### Products Affected

- Concord™ Hybrid Control Panels (part numbers 60-734-01, 60-801-01, 80-265, and 59-702-01-AR) with software version 3.0 shipped from May 26, 2003 to June 17, 2003.

### Identifying Concord Software 3.0 Boards with Incorrect E<sup>2</sup>PROM Chips in the Field

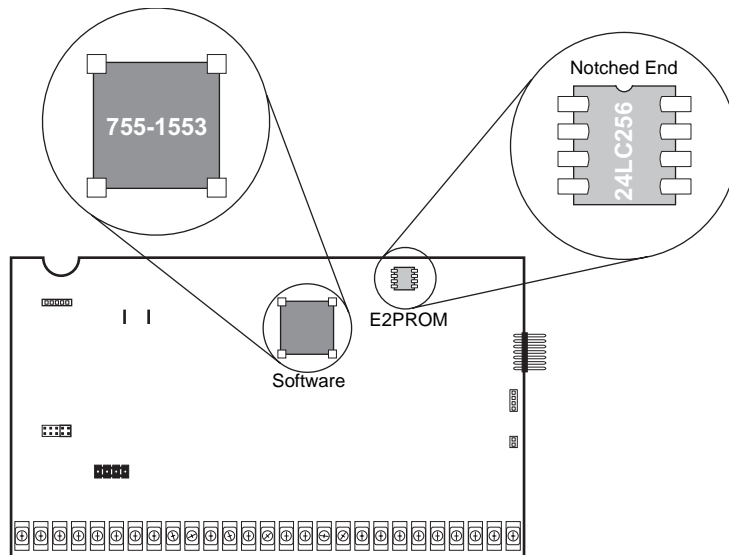
Some Concord panels with software version 3.0 were accidentally produced with the wrong E<sup>2</sup>PROM chip installed. For systems that include a SuperBus® 2000 Phone Interface/Voice Module, this causes either incorrect or no voice operation.

The graphic below shows the locations of the 3.0 software and E<sup>2</sup>PROM chips on the Concord board. The enlarged view of the chips show the correct part numbers. Any E<sup>2</sup>PROM chip with a different number must be replaced.

1. Check all installed and boxed panels to determine how many chips need replacing.
2. Contact GE Security Customer Support at 1-888-437-3287 to get free replacement E<sup>2</sup>PROM chips.
3. For panels not yet installed, simply remove the old chip and install the new one, making sure the notched end is positioned at the top.

6. Unplug the AC power transformer and disconnect the backup battery.
7. Remove the existing E<sup>2</sup>PROM chip.
8. Install the new chip, making sure the notched end is positioned at the top.
9. Discard the old chip.
10. Connect the backup battery and plug in the AC power transformer.
11. Reprogram the panel using ToolBox Downloader software or an on-site alphanumeric touchpad.
12. Test the system for correct operation.
